HISTORIC AND DESIGN REVIEW COMMISSION

HDRC CASE NO: 2015-186
ADDRESS: 921 MATAGORDA
LEGAL DESCRIPTION: NCB 716 BLK 1 LOT E IRR 91.98 FT OF 2
ZONING: C1 H HS
CITY COUNCIL DIST.: 1
DISTRICT: Lavaca Historic District
LANDMARK: McDowell, Rev W - House
APPLICANT: Robert Trevino
OWNER: Robert Trevino
TYPE OF WORK: Installation of a concrete ramp, walkway and fence removal
REQUEST:

The applicant is requesting a Certificate of Appropriateness for approval to:

BUILDING SITE PLAN

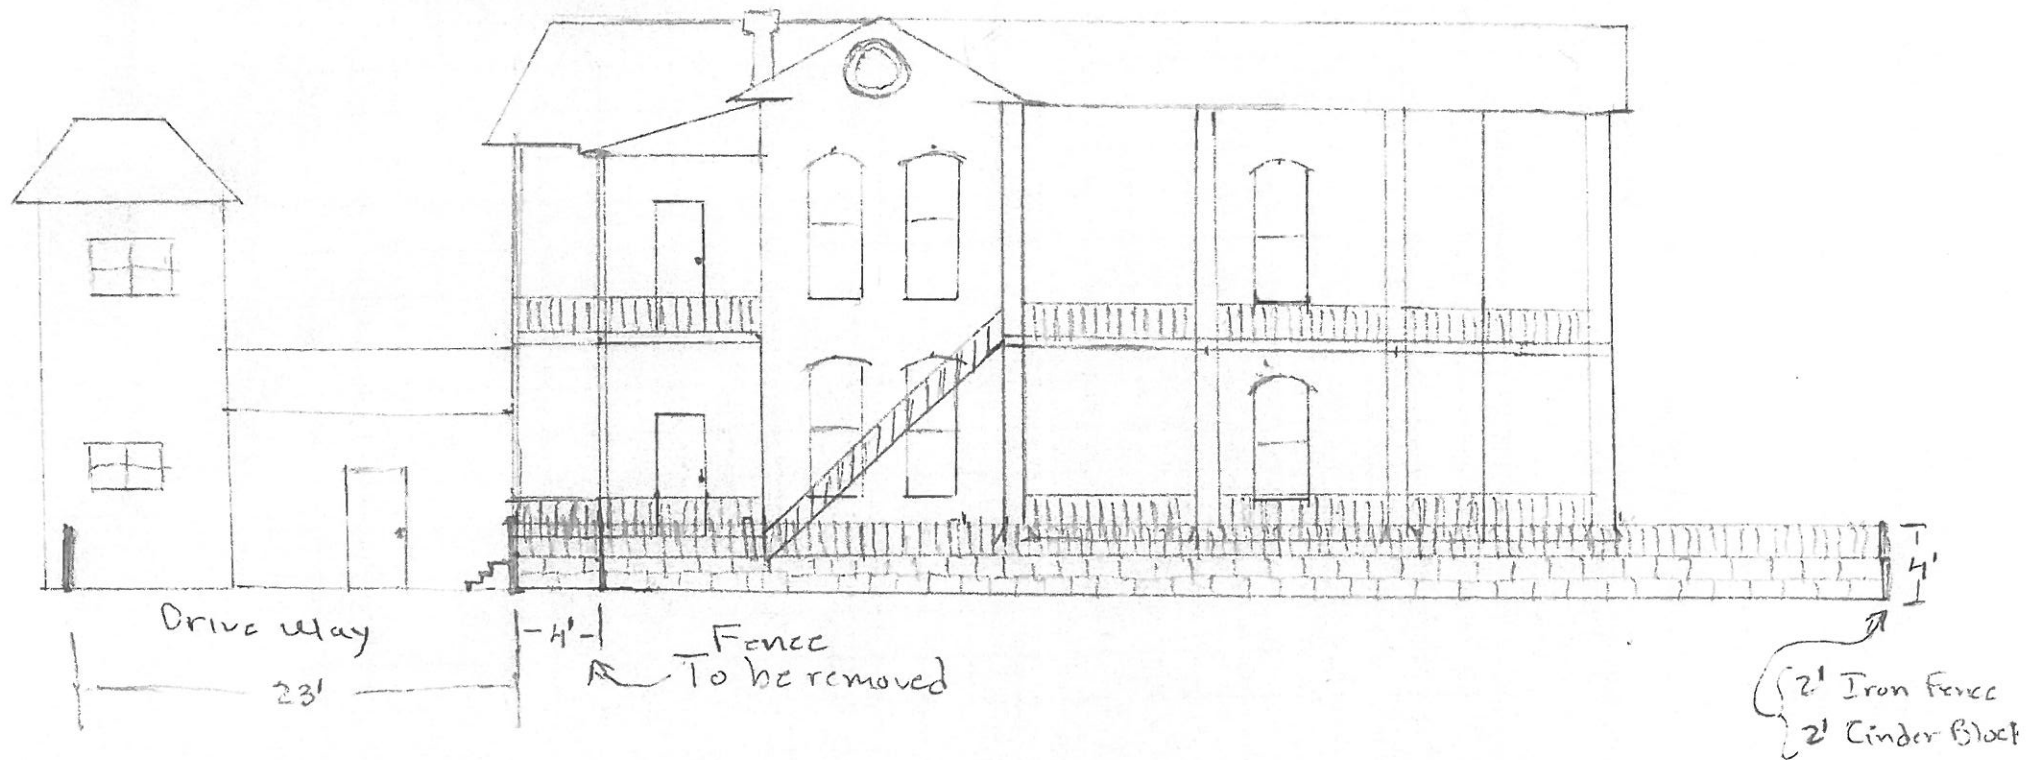
- b. Due to the structure's commercial zoning, the applicant has proposed to install an ADA compliant ramp that is to extend from the porch on the east (rear) façade of the house south along the existing driveway to the City of San Antonio sidewalk that runs parallel to Camargo. To connect to the City owned sidewalk parallel to Camargo, the applicant has proposed to remove a four (4) foot section of the existing site wall which consists of a wrought iron fence atop a stone base.

- c. The proposed concrete ramp is to be approximately thirty (30) inches tall and is to extend thirty (30) feet until it reaches grade. At that point the applicant has proposed an additional nine (9) feet of an onsite concrete sidewalk. The applicant's proposal to construct a concrete ramp as well as an additional nine (9) feet of an onsite concrete is consistent and appropriate with the Guidelines for Site Elements 8.A. and B. regarding the placement and introduction of a concrete ramp to the site. The applicant's proposal to construct the ramp at the rear of the historic structure is appropriate.

- d. The Guidelines for Site Elements 8.C.i. provides the guidelines for the elements of an ADA ramp. The Guidelines state that ramps should be designed to complement the historic structure of which they'll serve. The applicant has proposed for the ramp's railing to be thirty-six (36) inches in height, but has not provided information regarding materials. Staff recommends that the applicant include railing that complements that of house and wrought iron fence in color and visual appearance.

- e. Due to the location of the proposed ramp at the rear of the historic structure, the applicant has proposed to remove a four (4) foot section of the existing wrought iron fence that features a concrete base. While the removal of any complementary site element entirely is not appropriate, the applicant has proposed to keep the site fence in tact by removing a portion at the end of the fence near the existing driveway. This is appropriate and consistent with the Guidelines for Site Elements 2.A.i.

Staff recommends approval based on findings a through e with the stipulation that the applicant provide more information on the concrete ramp's railing that should be complementary to the wrought iron fence currently featured on the site. Staff recommends that the proposed concrete ramp's handrail match the color, diameter and detailing of the existing wrought iron fence currently featured on the property.
